THE MOORINGS NORTH

Re: S/D 9758 - One-Step Final Plat of THE MOORINGS NORTH 2ND ADDITION

Re: S/D 97-58 - One-Step Final Plat of THE MOORINGS NORTH 2ND ADDITION

CASE NUMBER: S/D 97-58 THE MOORINGS NORTH 2ND ADDITION

THE MOORINGS NORTH 2ND ADDN

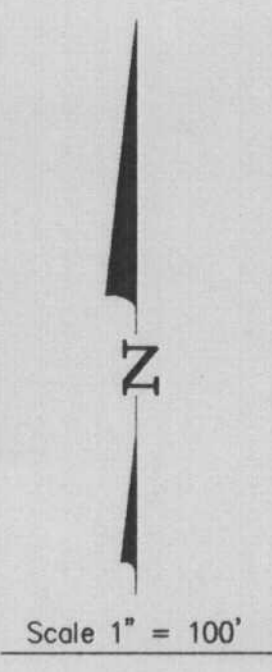
- D. The applicant shall guarantee any drainage improvements required by the platting of his property. The drainage plan has been approved. A minimum low opening shall be shown on the plat. (137 Wichita City Datum)

- V. The applicant's engineer/surveyor is asked to place a point of beginning on the drawing, as well as correct the bearings on the drawing to match those listed in the legal description. Along Bayview Drive the northwesterly most curve does not coordinate with the bearings and curvature shown in the legal description, this must be corrected prior to submitted a final tracing.

- BB. The final plat shall indicate, on the face of the plat and in the plat's text, that the entire area is subject to a required minimum low opening elevation of 1324.4 MSL unless City Engineering alters the minimum opening elevation.

- CC. In the plat's text, reserves in fifth sentence should read Reserve A and not the reserves.
- DD. The name on the face of the plat shall be called The Moorings North 2nd Addition.

NOTE:
1. THE MINIMUM LOW OPENING BUILDING ELEVATION FOR ALL LOTS IN THIS ADDITION IS 137.0 CITY OF WICHITA DATUM, (1324.4 MSL).
